**ELECTROLUX HOME PRODUCTS PTY LTD**  
ABN 51 004 762 341

Technical Bulletin N° CEB061.doc

## **IMPROVED HINGE SUPPORTS**

**OLD**

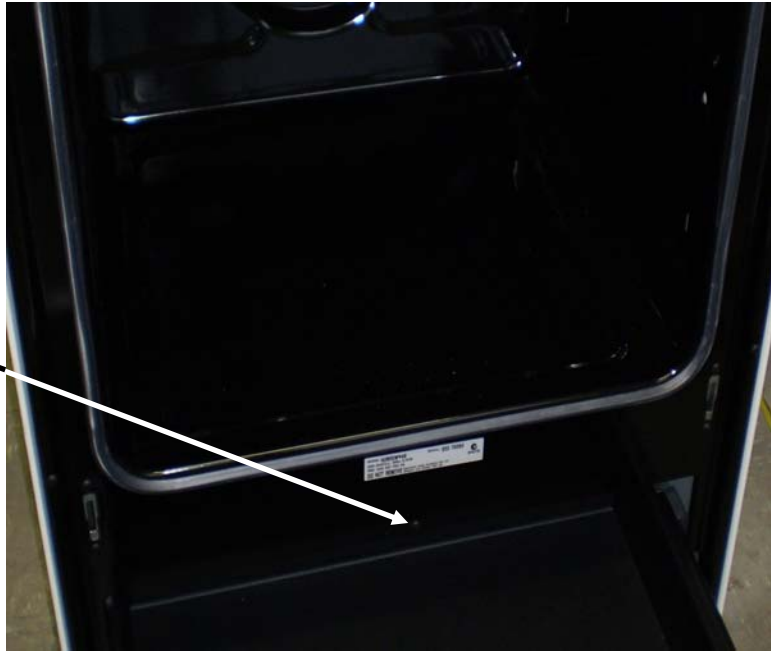
**Service:** An improved hinge support **0133 002 227** has been designed and can be fitted. On models produced before serial number **92970263** a kit will be required **0609 100 387**. This is due to the modification required to the warmer drawer panel deck for fitment of these supports. Please see overleaf for instruction on fitment.
